**TOPOGRAPHIC SURVEY  
SEASPECT SHORT PLAT  
JOHN KAHAN**

PERMIT DRAWINGS  
 DATE: 06.10.22  
 SHEET SIZE: D (24X36)  
 REVISIONS

PROJECT TITLE:  
**Clarkson Residence**  
8163 West Mercer Way  
Mercer Island, WA 98040

1 PROPOSED NORTH ELEVATION  
1/4" = 1'-0"

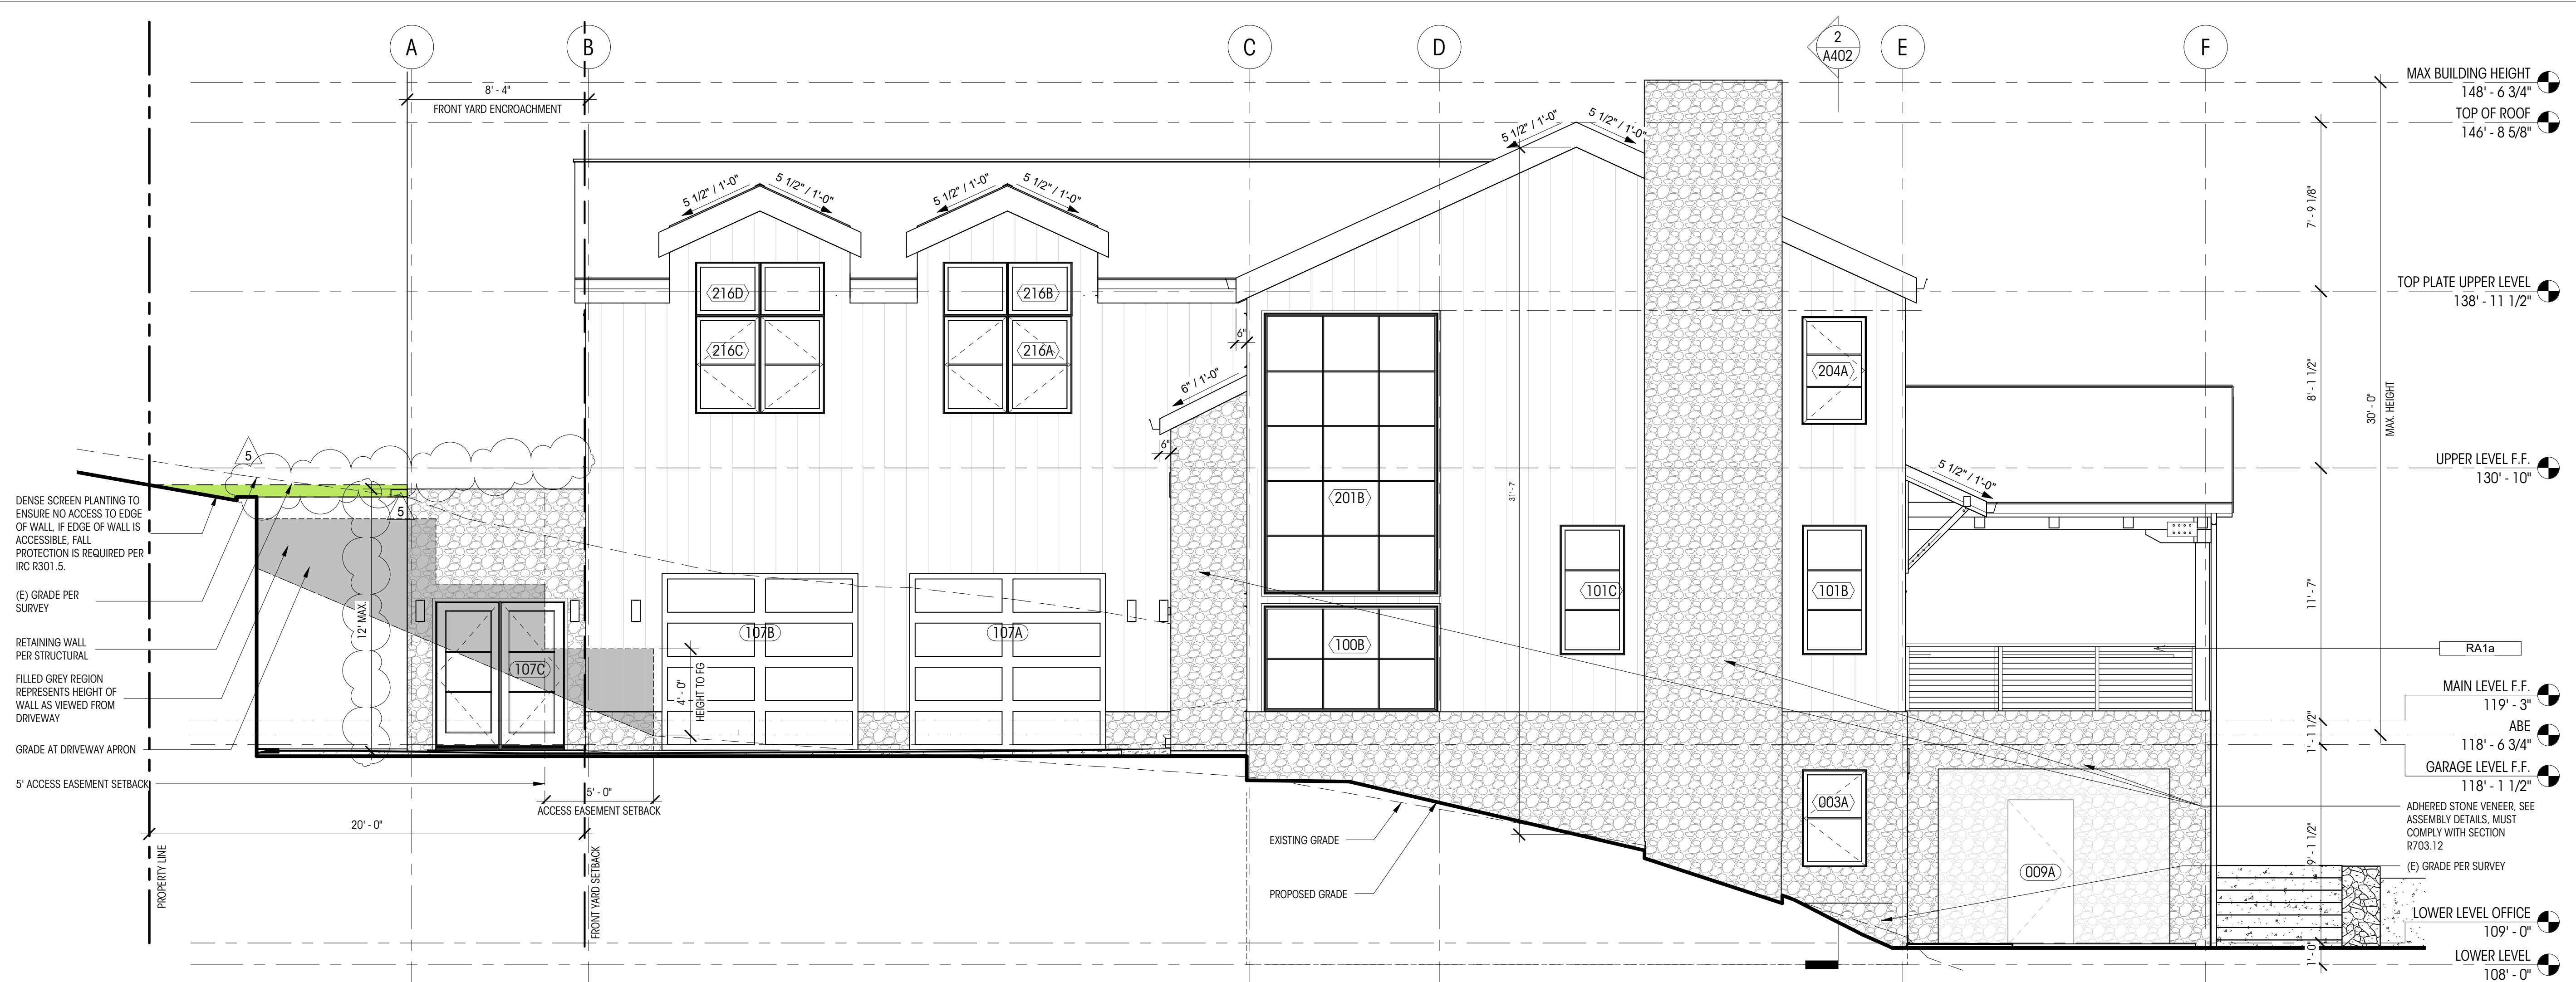
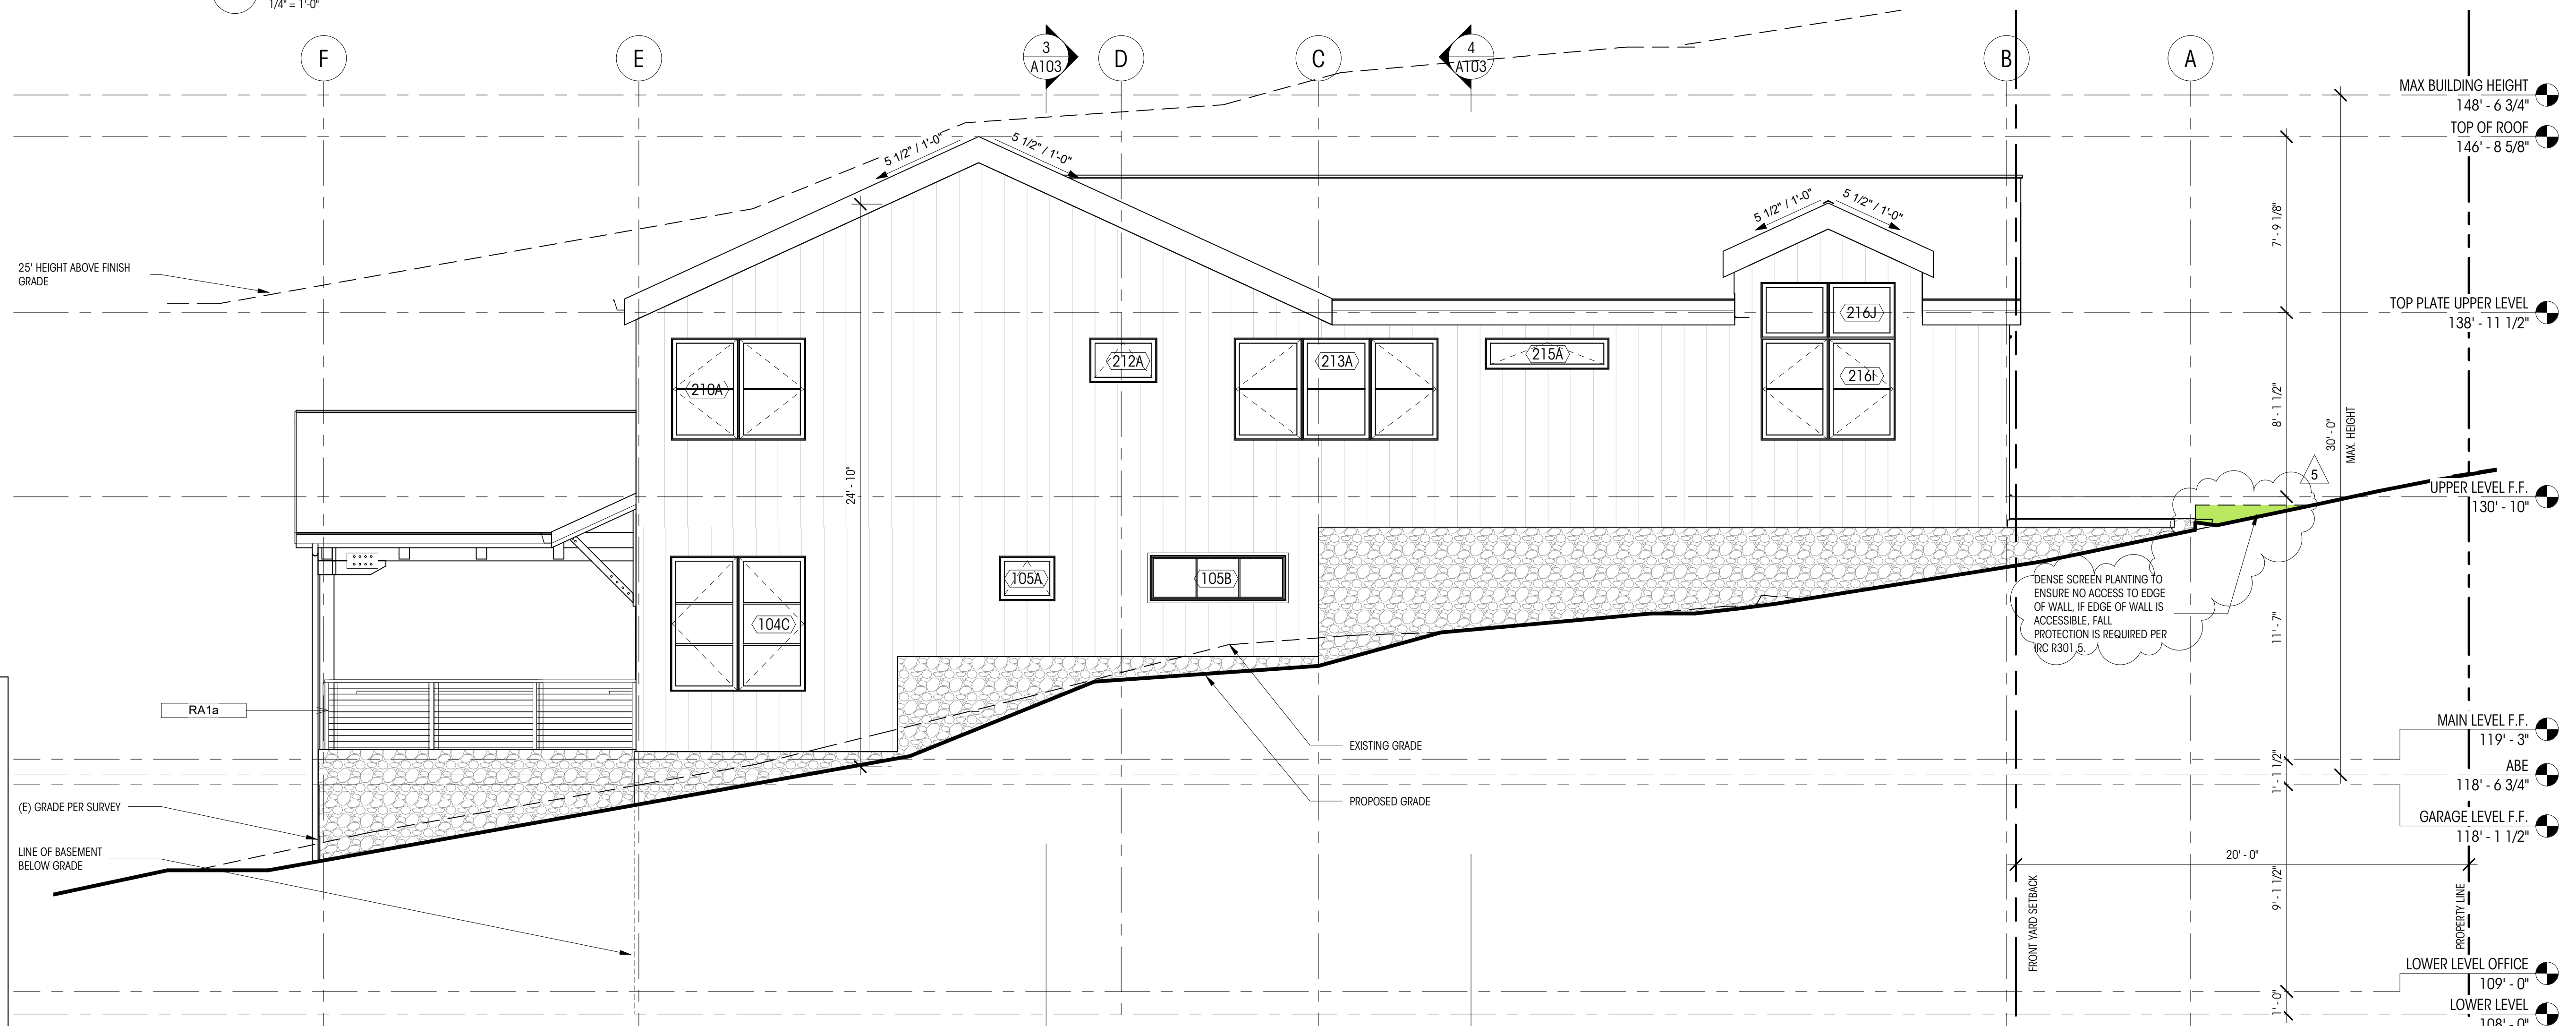
- CHANGE ROOF OF AND EXTEND WESTERN PATIO TO THE WEST AND SOUTH
- ADDED DORMERS AT UPPER LEVEL BONUS ROOM
- EXTEND GARAGE EAST INTO FRONT YARD SETBACK AS ALLOWED BY CODE 19.02.040.D
- WINDOW SIZE & LOCATION CHANGES
- LEVEL CHANGES:
  - a. DRIVEWAY & GARAGE LEVEL DROP BY 15"
  - b. BASEMENT LEVEL DROP BY 12"
  - c. UPPER LEVEL DROP BY 2"
  - d. FRAMED FLOOR 12" ABOVE BASEMENT FLOOR.
  - e. CHANGE TO ABE AS A RESULT OF EXTENDED GARAGE AND EXTENDED COVERED DECK
  - f. CHANGE TO MAX HEIGHT AS A RESULT OF THE ADJUSTMENT TO THE ABE.
  - g. TOP PLATE LEVEL ADJUSTED UP BASED ON ROOF FRAMING
  - h. ROOF OF ROOF HAS LOWERED AS A RESULT OF REDUCED ROOF PITCH
- SITE WALL MATERIAL CHANGE
- UPDATED STEPPING FOUNDATION WALL PROFILE TO MATCH STRUCTURAL

2 PROPOSED WEST ELEVATION  
1/4" = 1'-0"

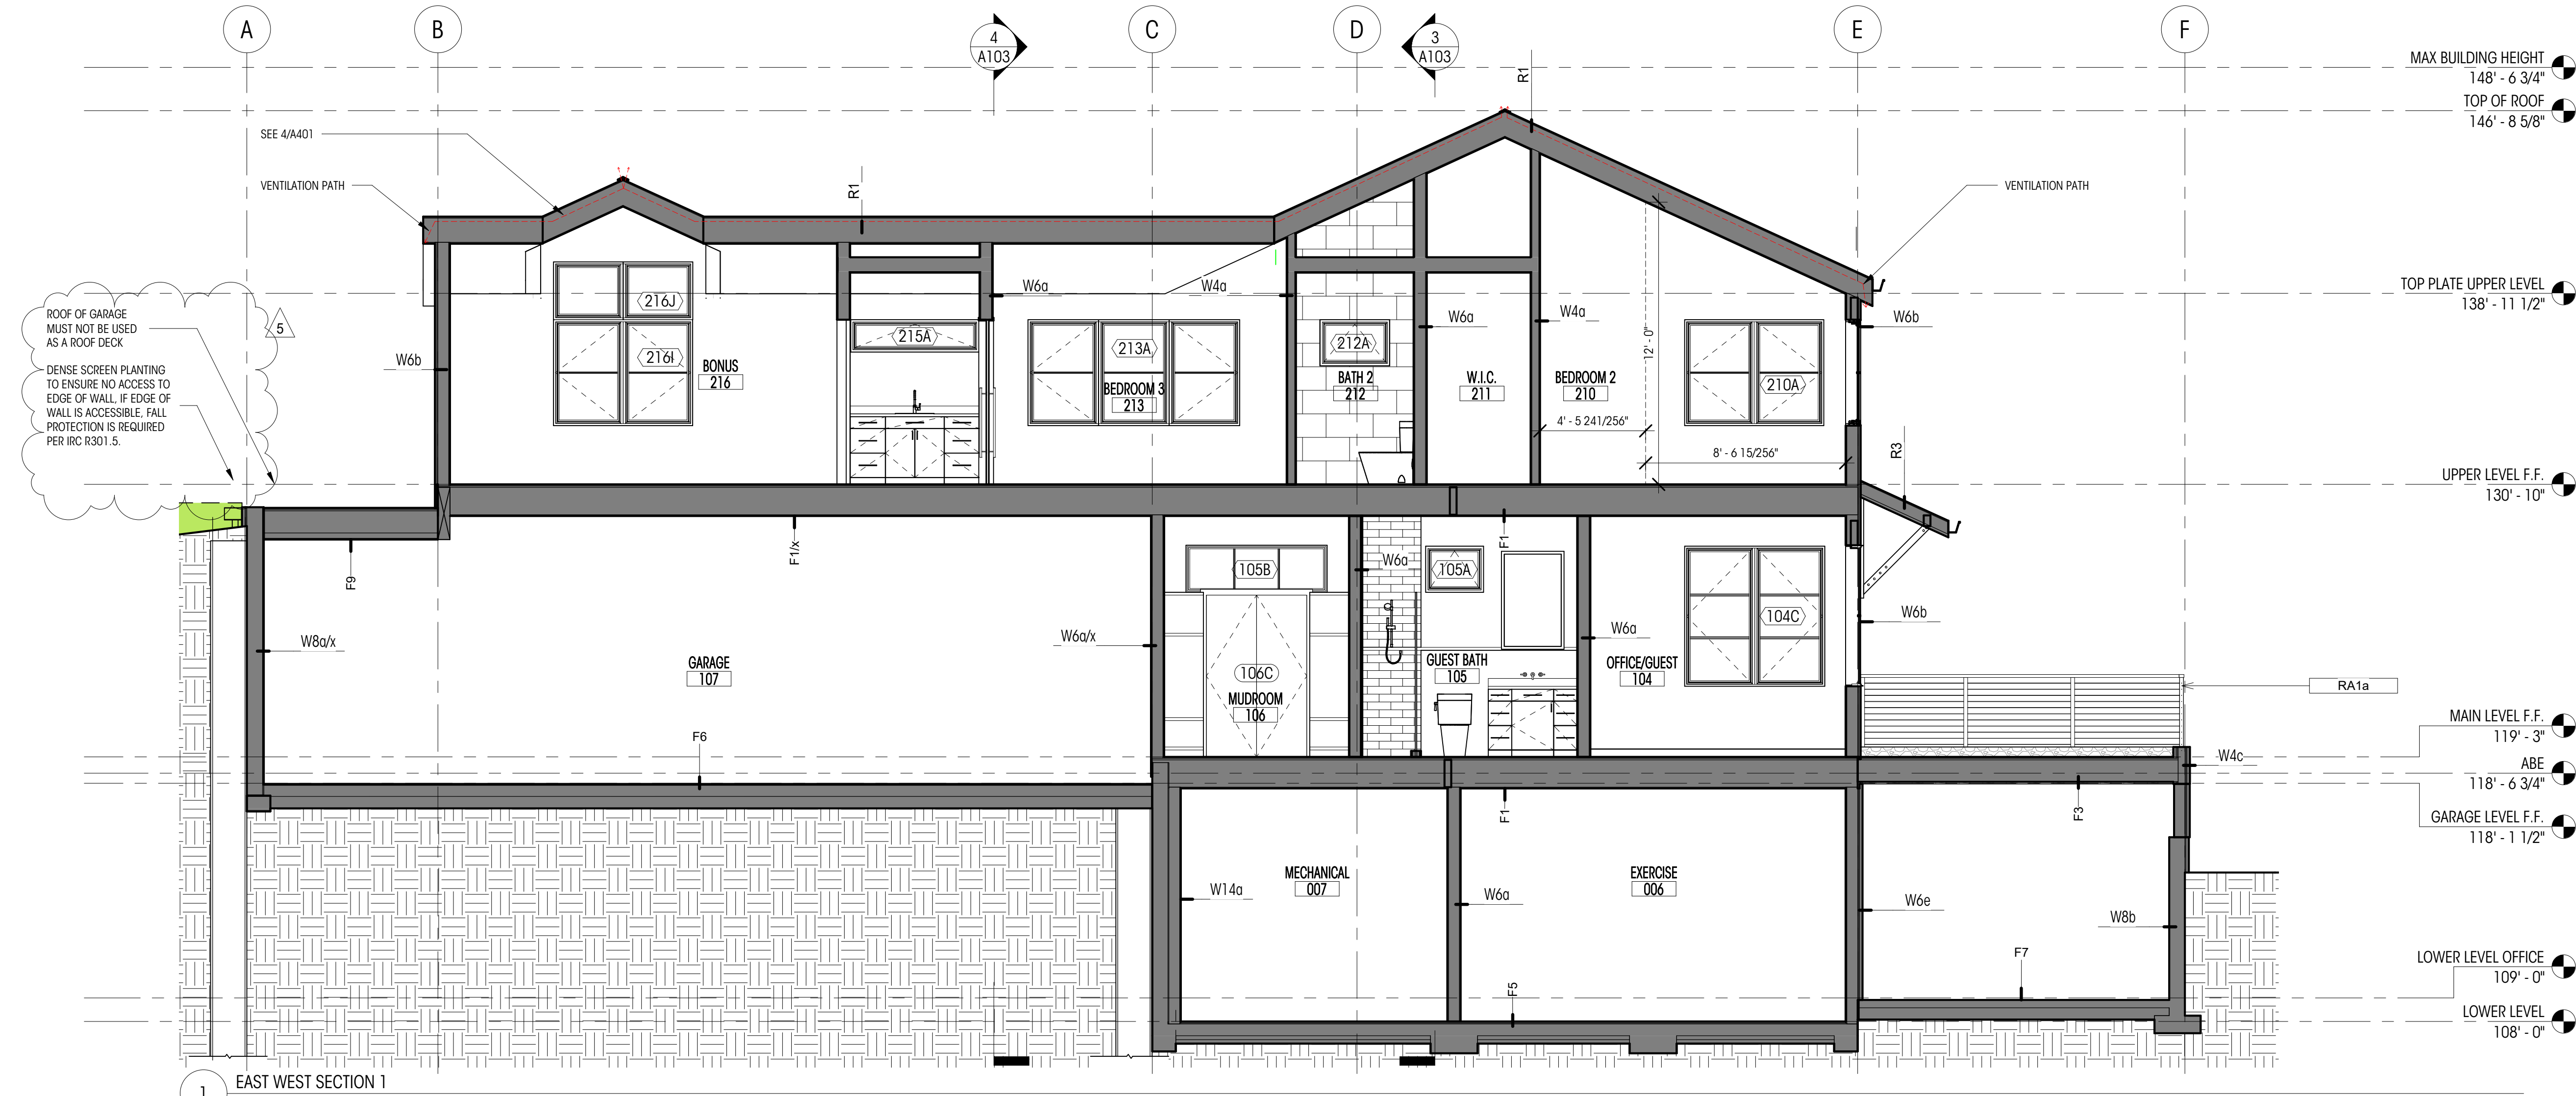
- CHANGE ROOF OF AND EXTEND WESTERN PATIO TO THE WEST AND SOUTH
- ADDED DORMERS AT UPPER LEVEL BONUS ROOM
- EXTEND GARAGE EAST INTO FRONT YARD SETBACK AS ALLOWED BY CODE 19.02.040.D
- WINDOW SIZE & LOCATION CHANGES
- LEVEL CHANGES:
  - a. DRIVEWAY & GARAGE LEVEL DROP BY 12"
  - b. BASEMENT LEVEL DROP BY 12"
  - c. FRAMED FLOOR 12" ABOVE BASEMENT FLOOR.
  - d. CHANGE TO ABE AS A RESULT OF EXTENDED GARAGE AND EXTENDED COVERED DECK
  - e. CHANGE TO MAX HEIGHT AS A RESULT OF THE ADJUSTMENT TO THE ABE
  - f. TOP PLATE LEVEL ADJUSTED UP 2 5/8".

2 EAST WEST THROUGH ENTRY  
1/4" = 1'-0"

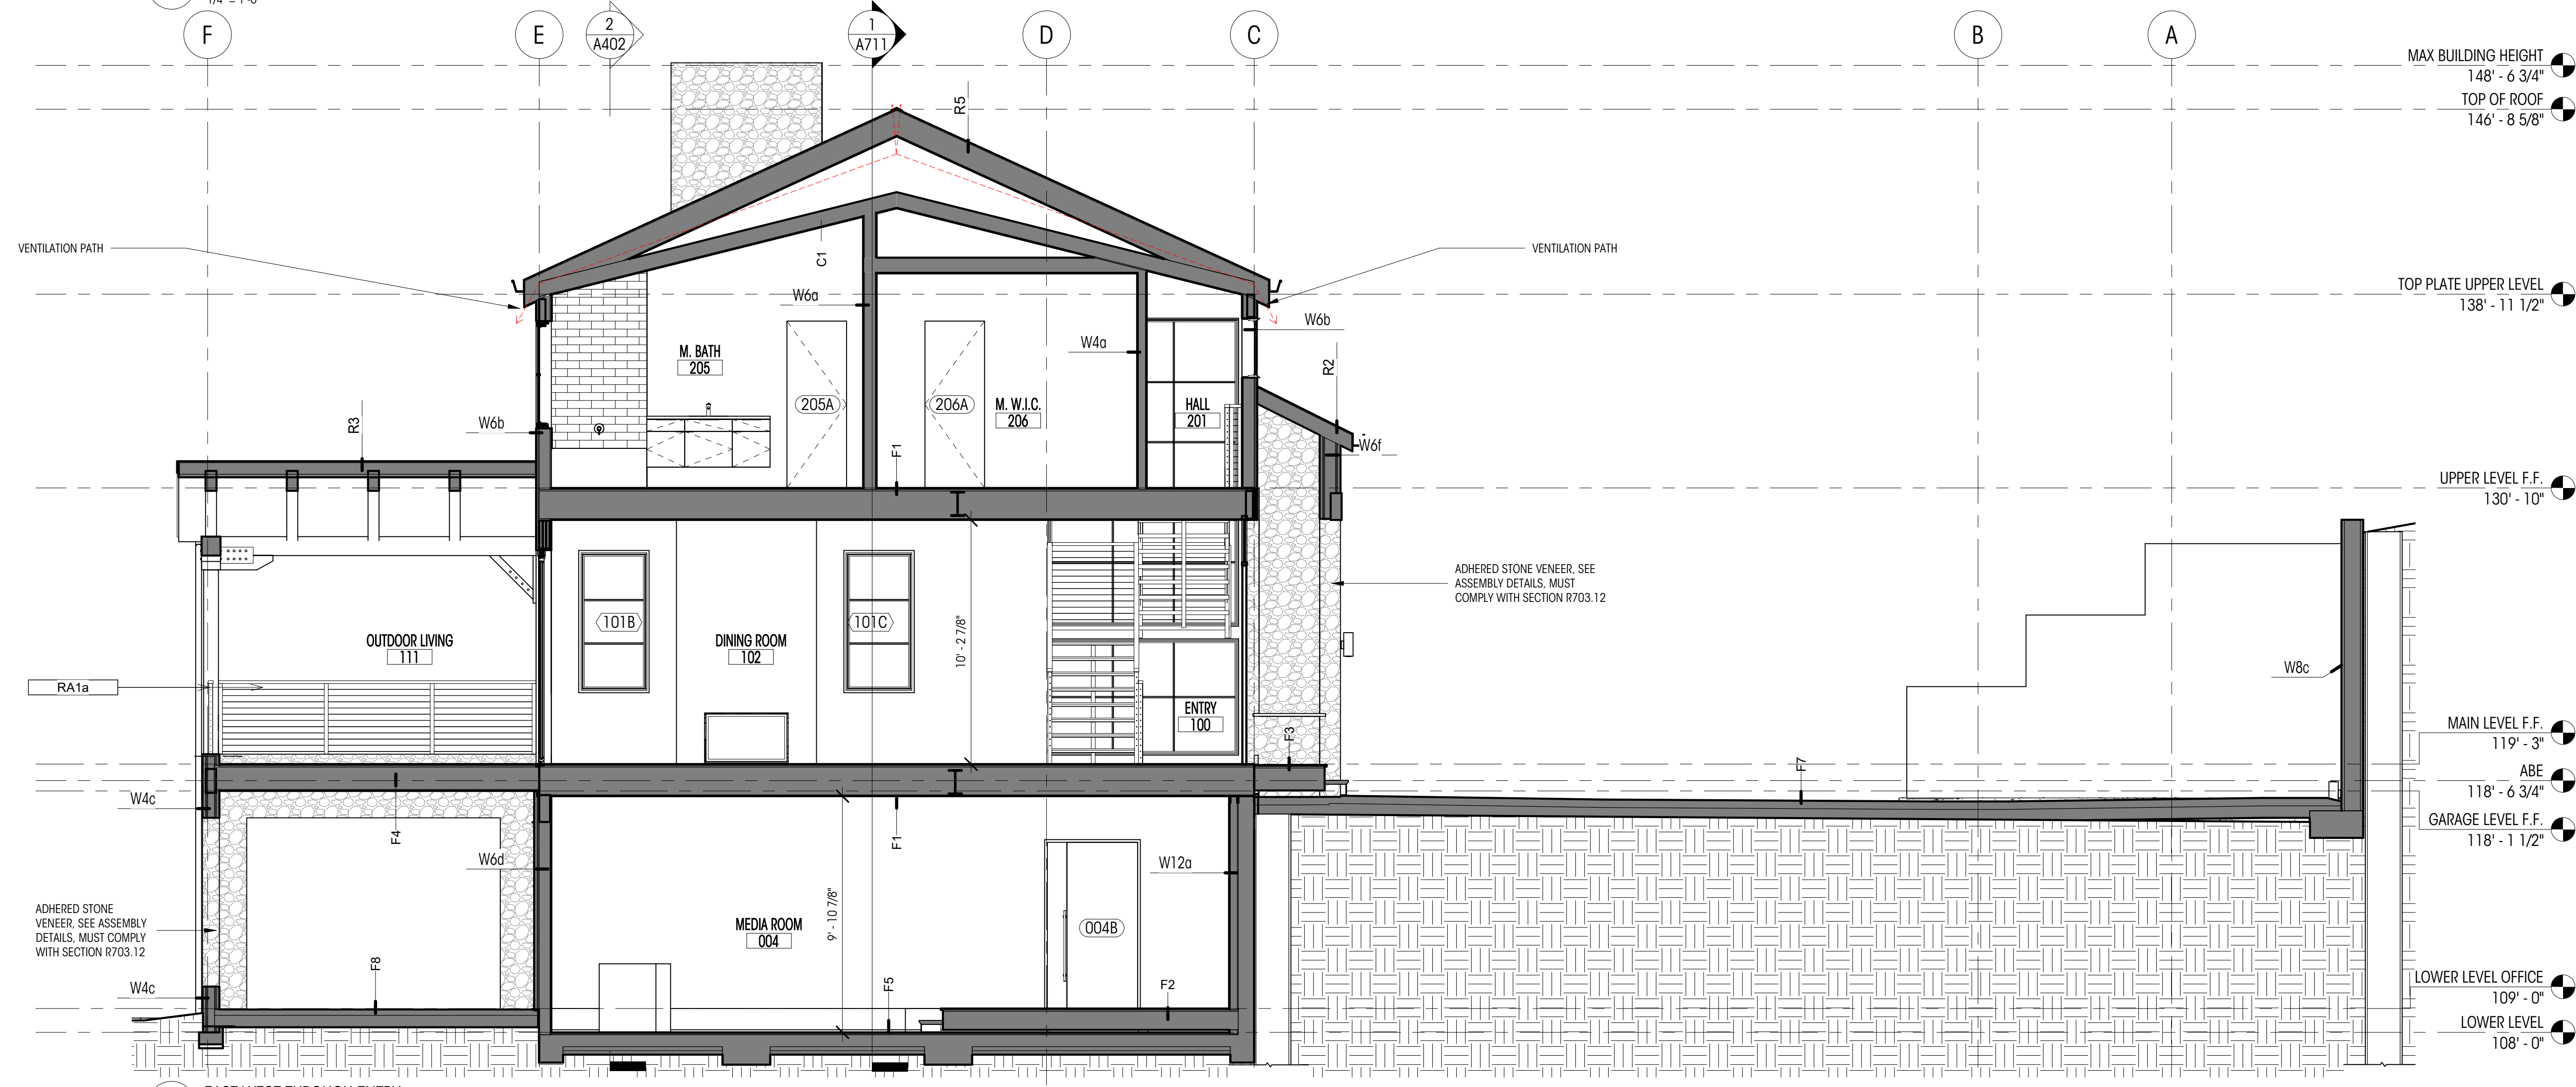
- VIEW NUMBERING UPDATED AND ADJUSTED FOR CLARIFICATION
- CHANGE ROOF OF AND EXTEND WESTERN PATIO TO THE WEST AND SOUTH
- ENTRY DESIGN CHANGE
- ADDED DORMERS AT UPPER LEVEL BONUS ROOM
- EXTEND GARAGE EAST INTO FRONT YARD SETBACK AS ALLOWED BY CODE 19.02.040 D
- SHEET LAYOUT ADJUSTED FOR ORGANIZATIONAL PURPOSES
- PREVIOUS "VIEW 1" HAS MOVED TO SHEET A401 AND STAYED "VIEW 1"
- LEVEL CHANGES:
  - a. DRIVEWAY & GARAGE LEVEL DROP BY 15"
  - b. BASEMENT LEVEL DROP BY 12"
  - c. UPPER LEVEL DROP BY 2"
  - d. FRAMED FLOOR 12" ABOVE BASEMENT FLOOR.
  - e. CHANGE TO ABE AS A RESULT OF EXTENDED GARAGE AND EXTENDED COVERED DECK
  - f. CHANGE TO MAX HEIGHT AS A RESULT OF THE ADJUSTMENT TO THE ABE
  - g. TOP PLATE LEVEL ADJUSTED UP BASED ON ROOF FRAMING
  - h. ROOF OF ROOF HAS LOWERED AS A RESULT OF REDUCED ROOF PITCH
